To: Willmott Dixon
Attention: Tom Farrow
From: MACH Acoustics
Date: 30/05/2019
Project: University of Hertfordshire Sport Science
Subject: Early Stage Risk Assessment of the M&E Rooftop Noise Breakout

Figure 1: Plant Locations

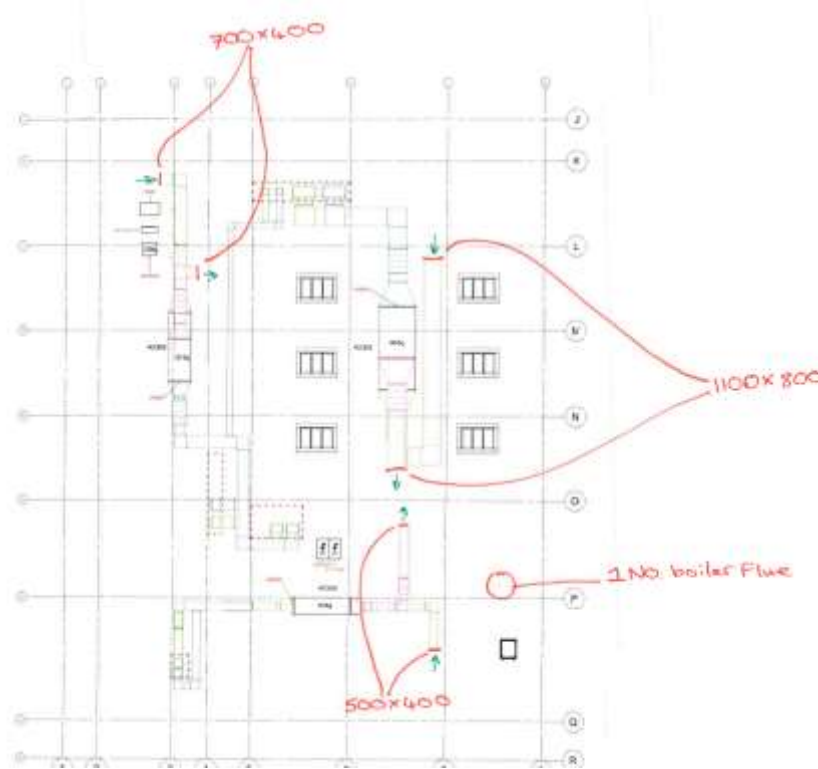
The figure below illustrates the proposed rooftop equipment locations at this stage.

Residential areas along St Alban Road West to the south of the site are seen to be the worst effected receptors from the proposed rooftop plant. At this stage, the specification of attenuators for service terminals are not available. Based upon the given plant noise limits in Table 2, plant noise rating level has been provided at 1m away from the rooftop plant zone. In order to assess the worst case scenario, all associated equipment and duct terminations have the minimum distance of 57m to the receptors.

Note: Table 4 is for guideline only. As the design progresses and the attenuator specified, a detailed assessment will be carried out at later stage to ensure the proposed M&E rooftop design complies with the planning noise breakout targets.
